Architect's Supplemental Instructions

Architect's ASI No: 051

Project:
Webster University
Interdisciplinary Science
Building

ASI-051 is being issue for the purpose of providing a mechanical equipment condensate drain connection to the plumbing waste system.

M0105.A

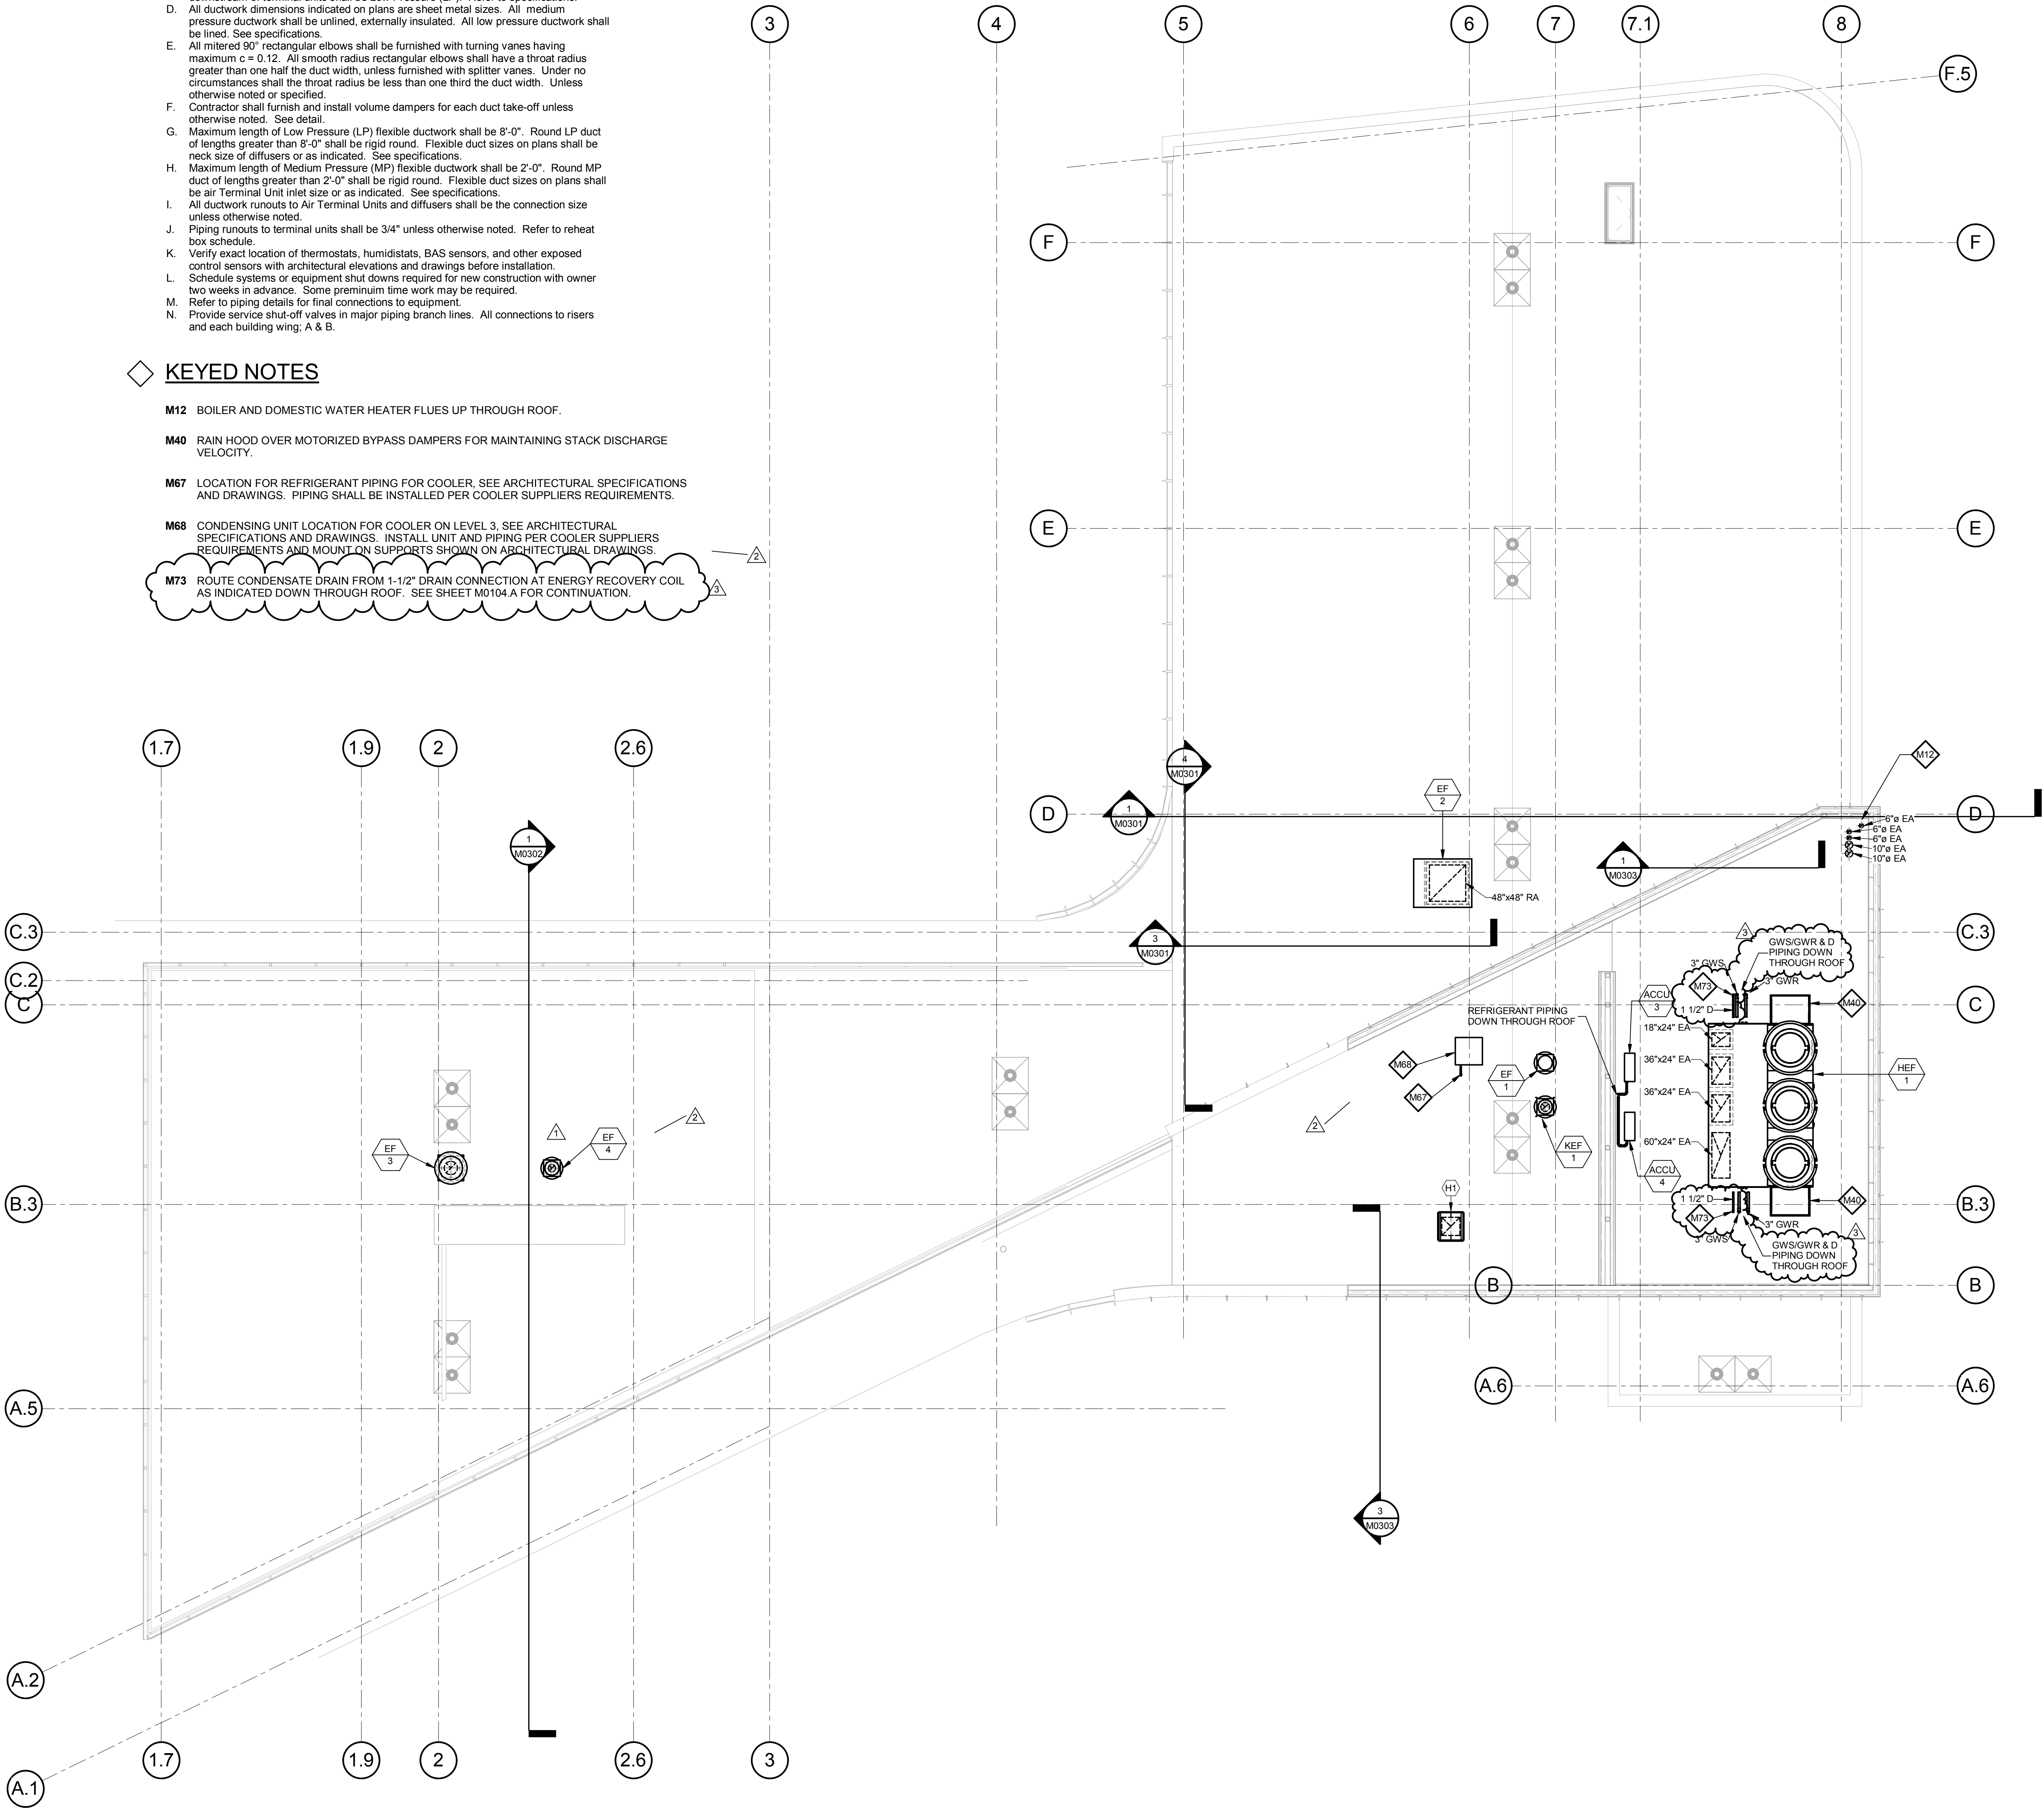
SHEET M0105.A – ROOF PLAN – MECHANICAL

- Added drain lines down through roof from HEF-1.
- Added note M73.

M73 ROUTE CONDENSATE DRAIN FROM 1-1/2" DRAIN CONNECTION AT ENERGY RECOVERY COIL AS INDICATED DOWN THROUGH ROOF. SEE SHEET M0104.A FOR CONTINUATION.

P0114.A

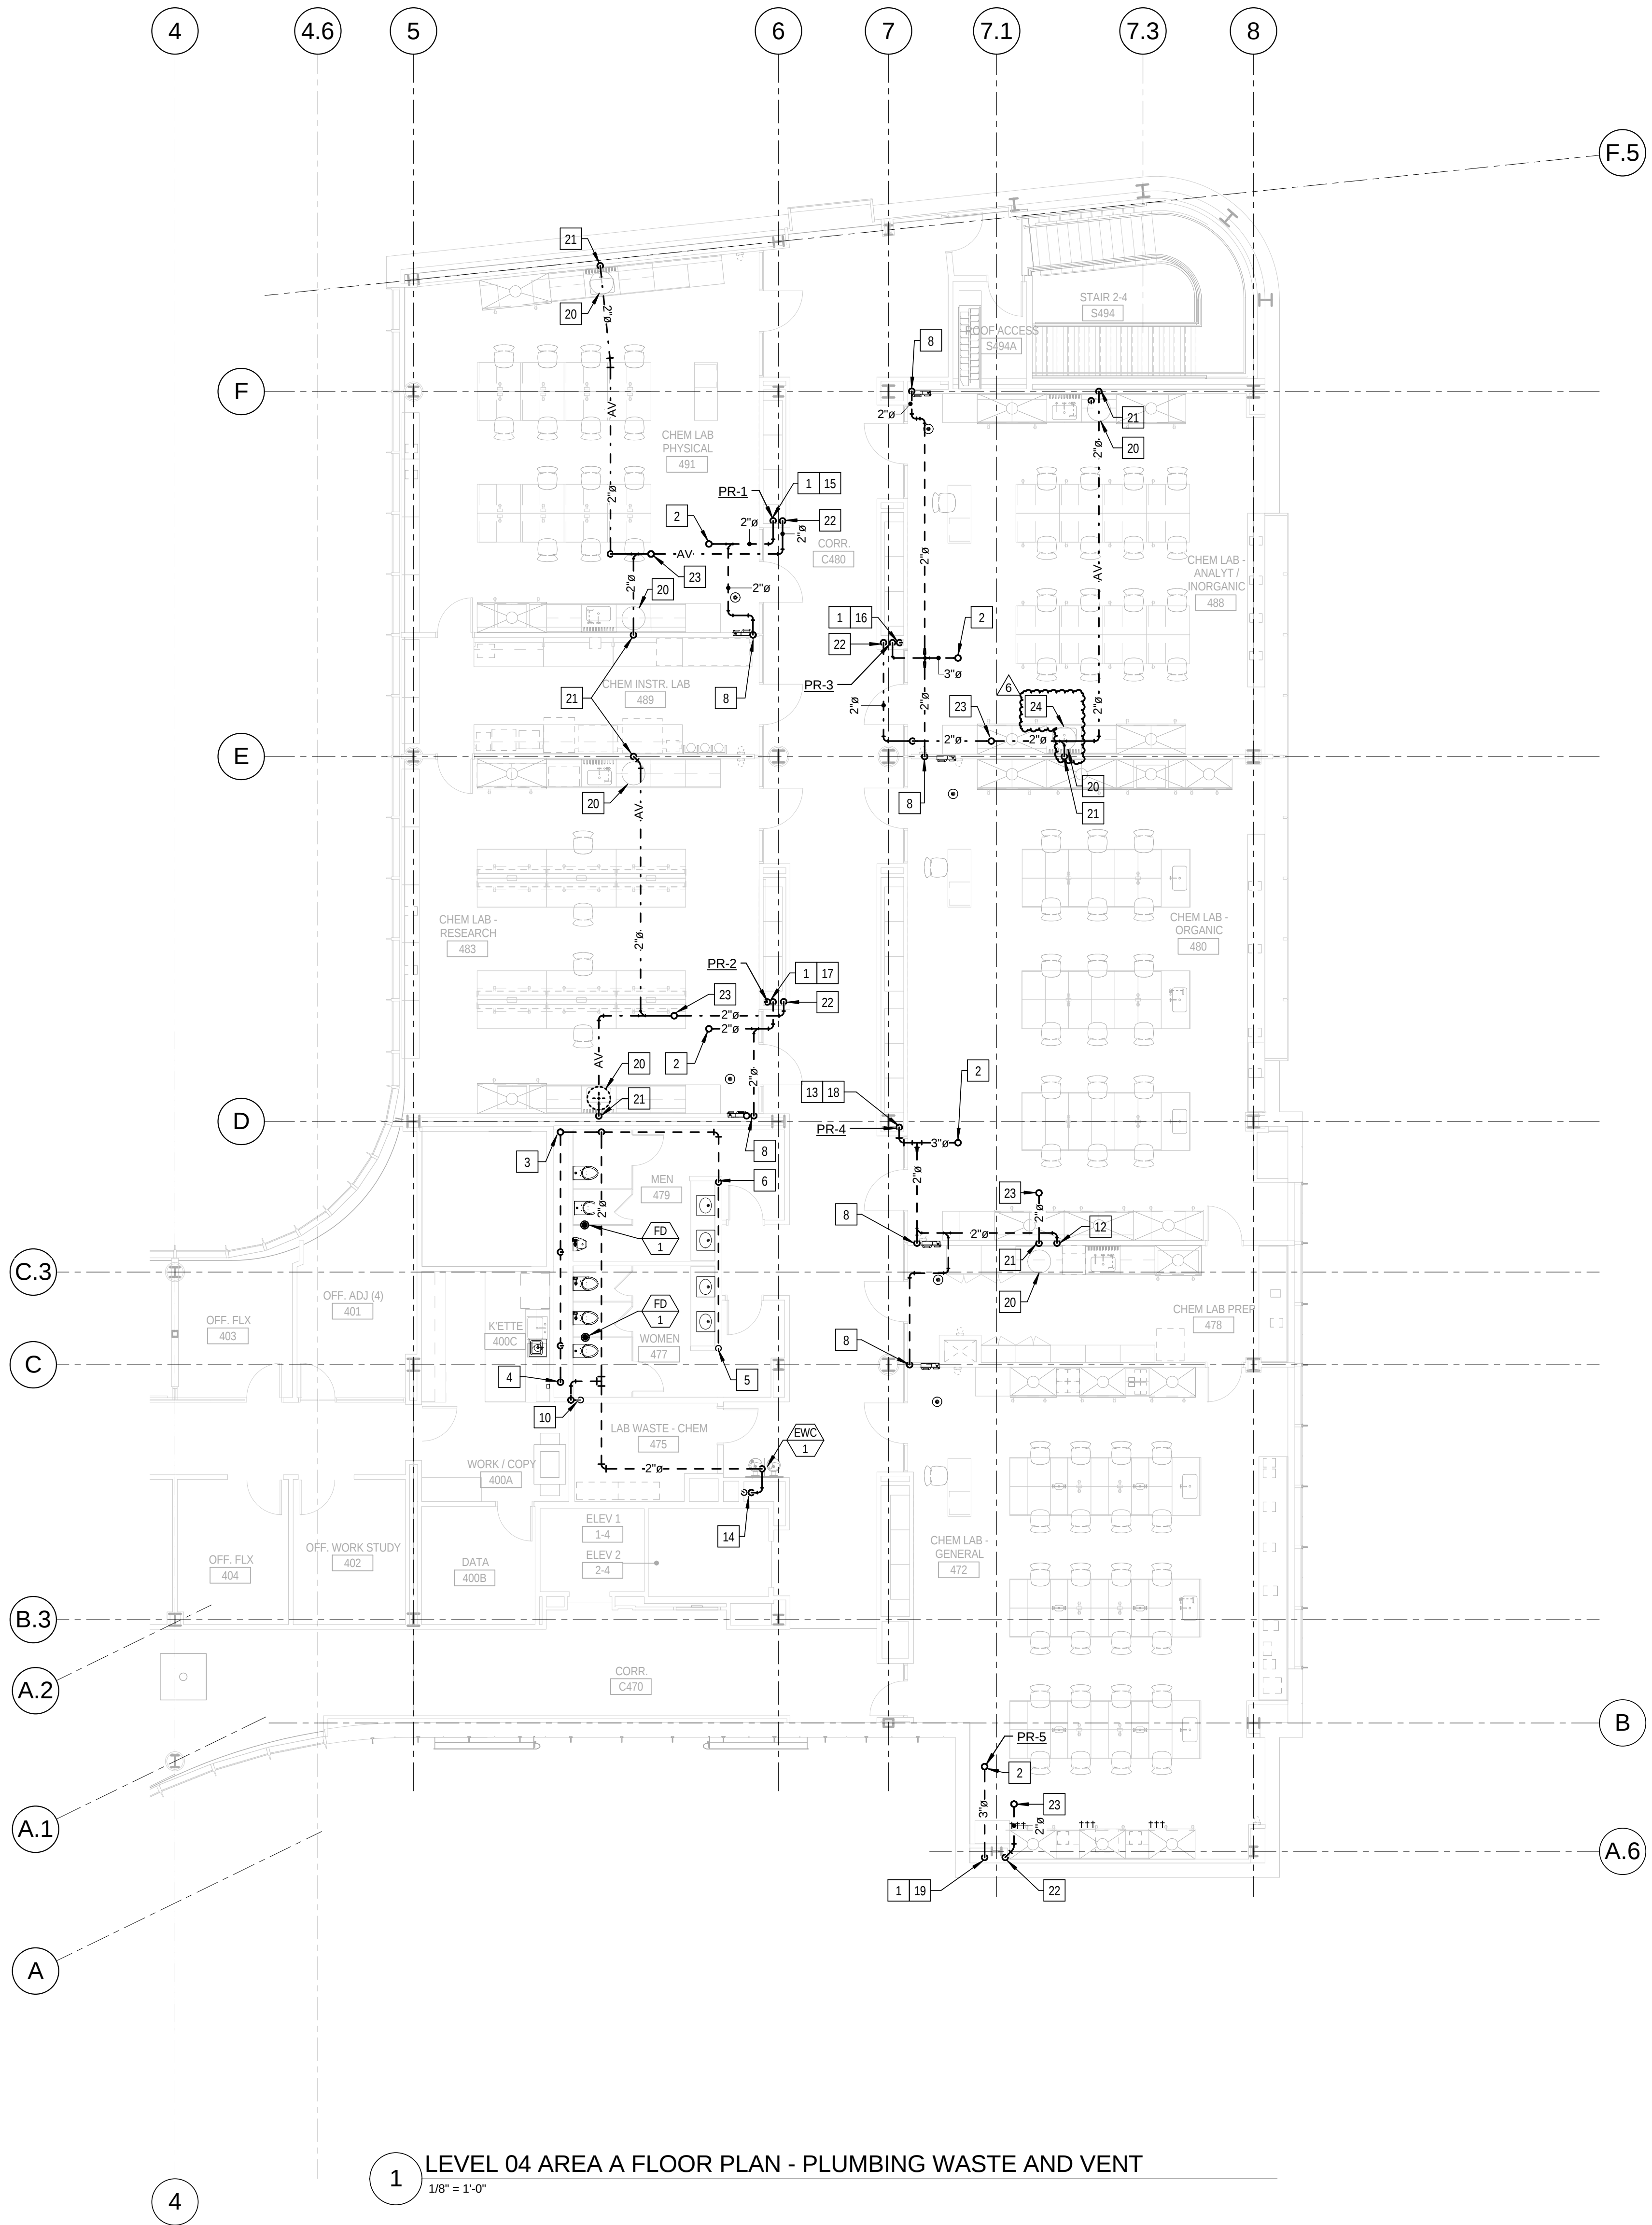
SHEET P0114.A – LEVEL 04 AREA A FLOOR PLAN – PLUMBING WASTE AND VENT

- Added key note 24 to modify waste piping in Chem. Lab – Analyt./ Inorganic 488, at lab sink along column line 'E'.

24 WASTE PIPING ON IN-LET SIDE OF NEUTRALIZATION TANK TO BE MODIFIED TO ACCEPT 3/4" CONDENSATE DRAIN BY MECHANICAL CONTRACTOR. COORDINATE REQUIREMENTS WITH MECHANICAL CONTRACTOR. REFER TO DETAIL 3 ON DRAWING P0404.

3 NEUTRALIZATION TANK PIPING DIAGRAM FOR UNDER SINK INSTALLATION-LAB 488

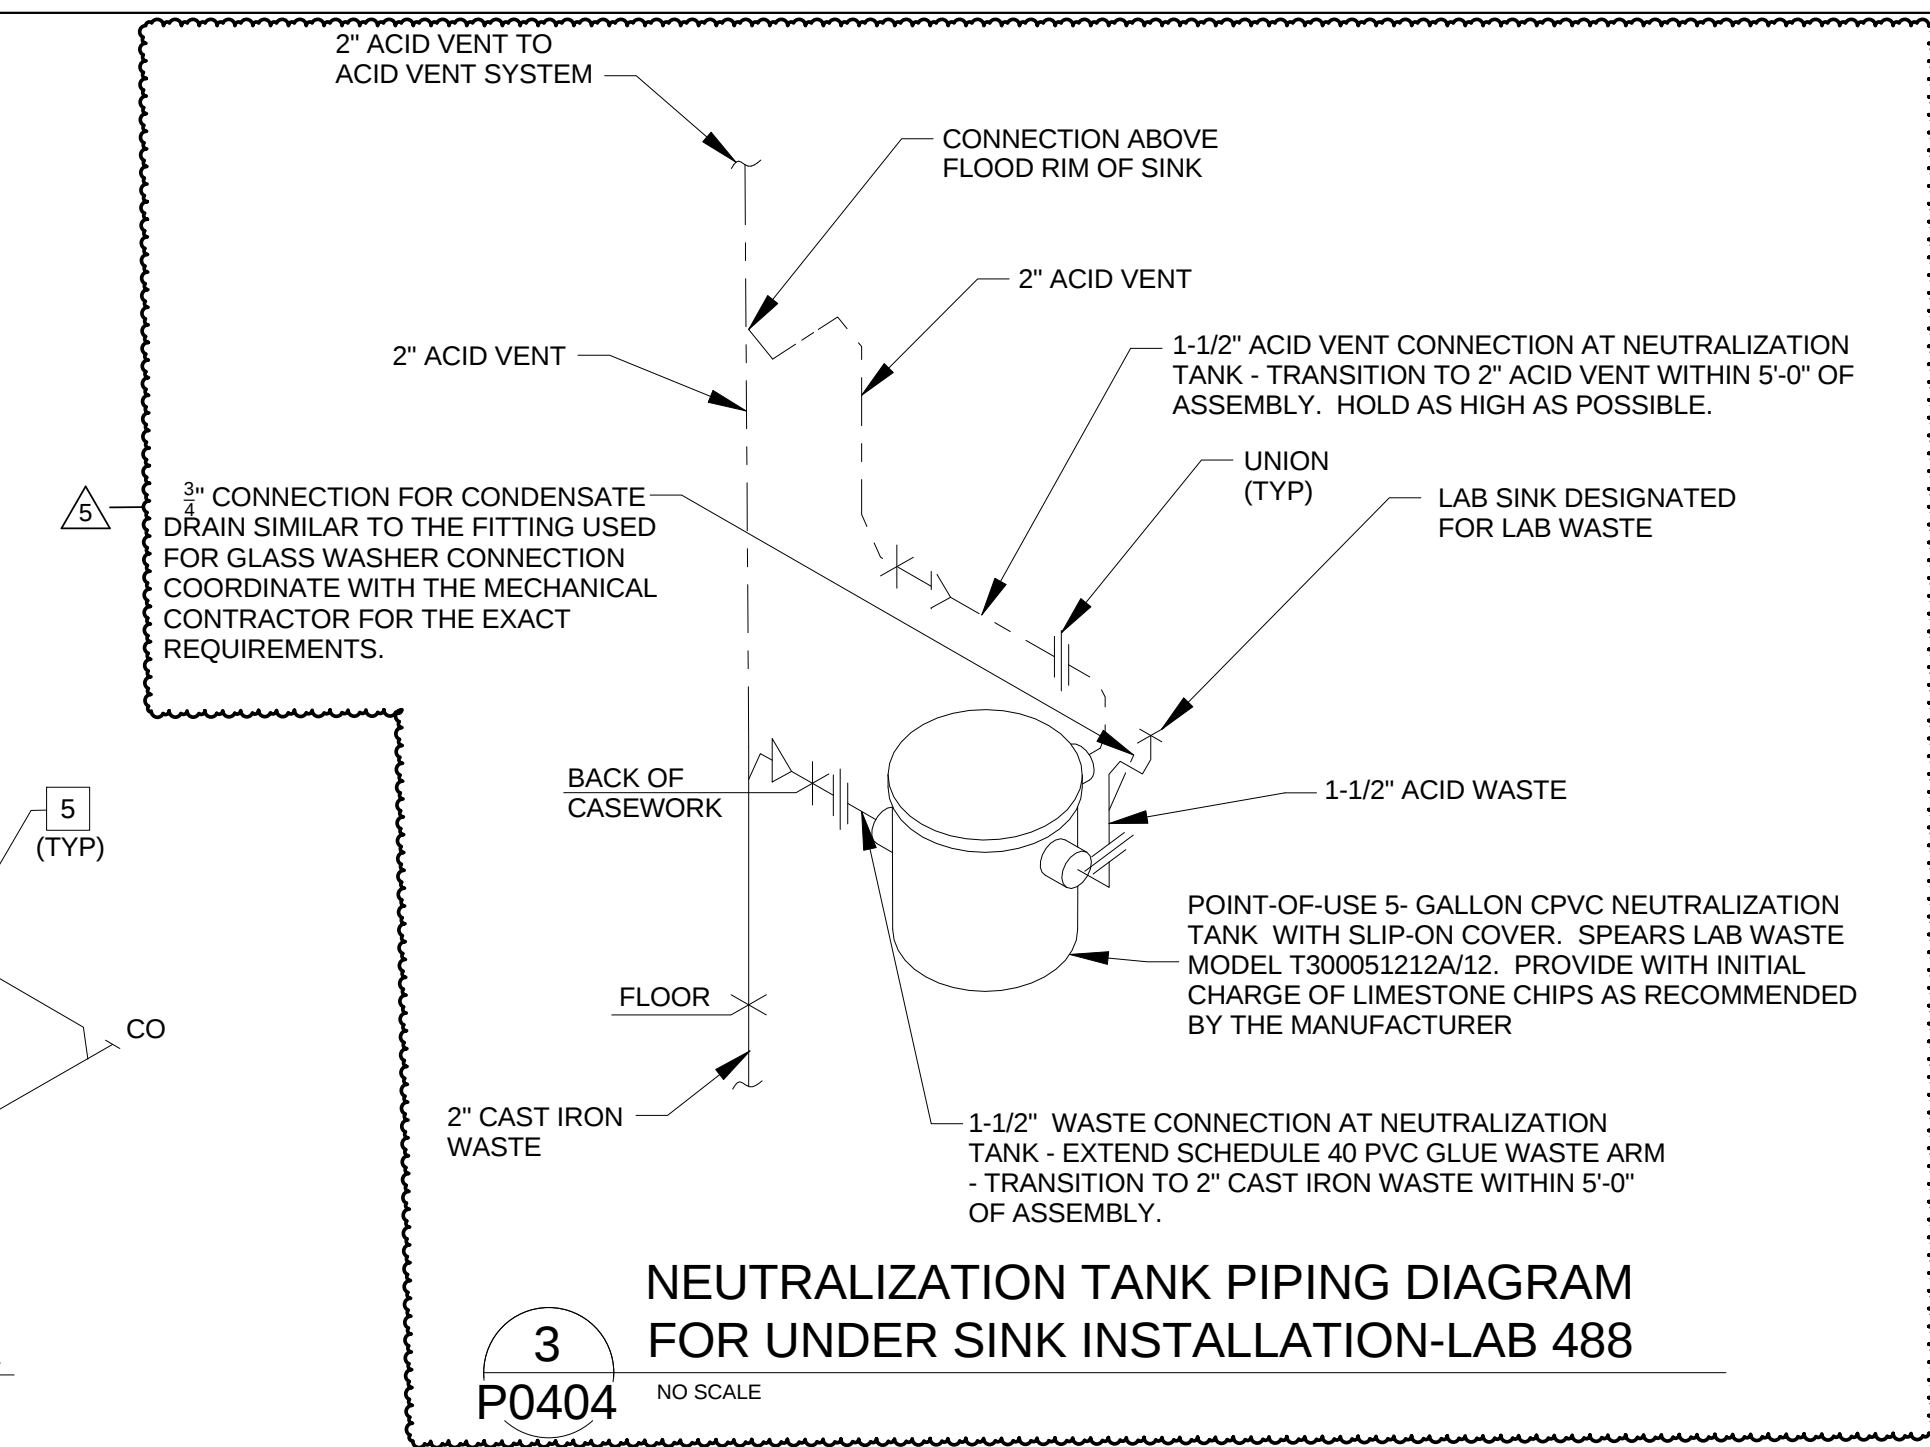
SHEET P0404 - RISERS PLUMBING

- Added riser diagram 3.
